Groundwater and Wastewater Services File Imaging Project

APPLICATION FOR SOIL INVESTIGATION

SITE EVALUATION

RE: Property located at Henderson Circle, Lots 72-75

**See Diagram on Back (includes: soil areas, property lines, roads, streams, gullies, wet areas, fill areas, wells, water bodies, slopes)

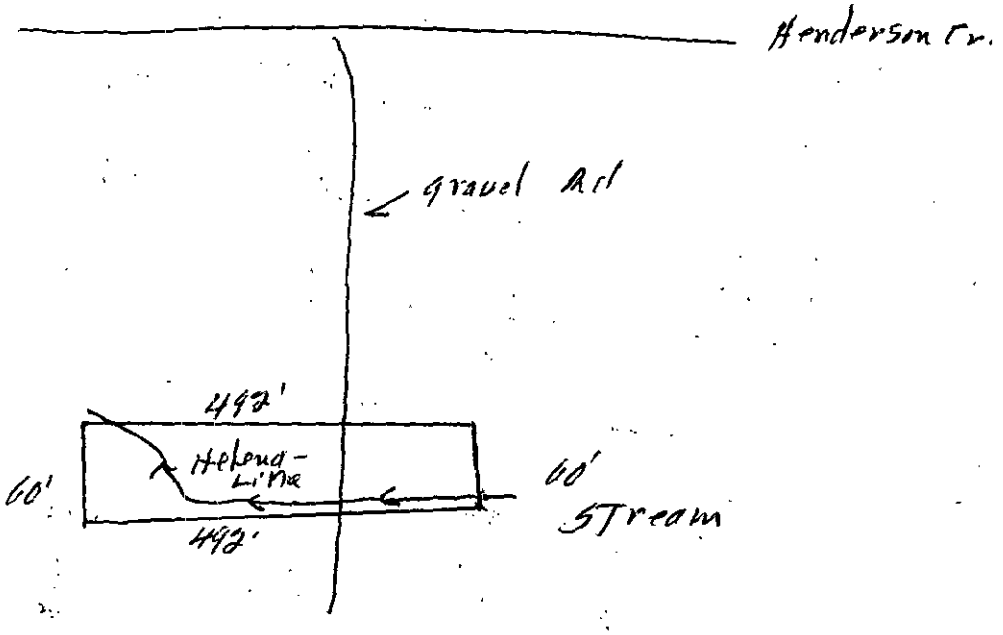
FACTORS	AREA 1	AREA 2	AREA 3	AREA 4
1. SLOPE (%)	(S) 8-15% / PS / U	S / PS / U	S / PS / U	S / PS / U
2. SOIL TEXTURE (12-36 inches) Sandy, Loamy, Clayey (Note 2-1 Clay)	S 2-1 / PS Clay / (U)	S / PS / U	S / PS / U	S / PS / U
3. SOIL STRUCTURE (12-36 inches)	S / (PS) Blocky / U	S / PS / U	S / PS / U	S / PS / U
4. SOIL DEPTH (inches)	S / (PS) 36-40" / U	S / PS / U'	S / PS / U	S / PS / U
5. RESTRICTIVE HORIZONS (Inches) (Impervious strata, Rock)	S 36" / (PS) / U	S / PS / U	S / PS / U	S / PS / U
6. SOIL DRAINAGE/GROUNDWATER (external and internal)	S Perched / PS water / (U) table	S / PS / U	S / PS / U	S / PS / U
7. OTHER (Specify)	S 18-20" / PS / U	S / PS / U	S / PS / U	S / PS / U
8. SOIL GROUP	1UB			
9. SITE CLASSIFICATION	unsuitable			
10. SOIL SERIES	Helena-Urban Land

Henderson Rd.
gravel Rd
492'
Helena-
Lima
60'
60'
Stream
492'
